Product hierarchy no. *				Part no.	SBU	Type / Description	Customer part no.
SBU	PG	PUG	Type				
02	007	001	0000002310	6160.0001	Connector	2561 Appliance Inlet C6	n/a
				6160.0080		2561 Appliance Inlet C6	n/a
				6160.0082		2561 Appliance Inlet C6	n/a
				6160.0086		2561 Appliance Inlet C6	n/a
				6160.0088		2561 Appliance Inlet C6	n/a

Product Change Notification					2561 Change of marking		
owner	creation date	release date	released by	change order no	rev	page	D10-052-362
zeierjo	31.03.2021	31.03.2021	muehlema	2019985	B	1 of 1

3 Detailed description of change

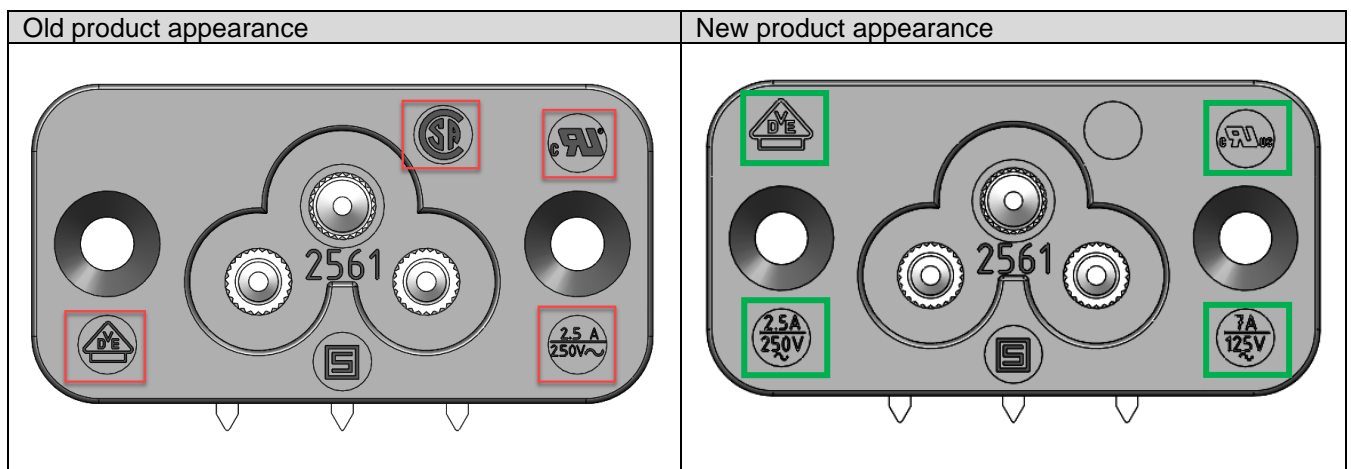
UL upgrade from UL 498 to UL 60320-1.
Marking for UL rating 7A/125V~ added. CSA / UR replaced by cURus.

Form	Yes	Change of approval and rating marking.
Fit	No	-
Function	No	-
Manufacturing	No	-
Label	No	-
Packaging	No	-
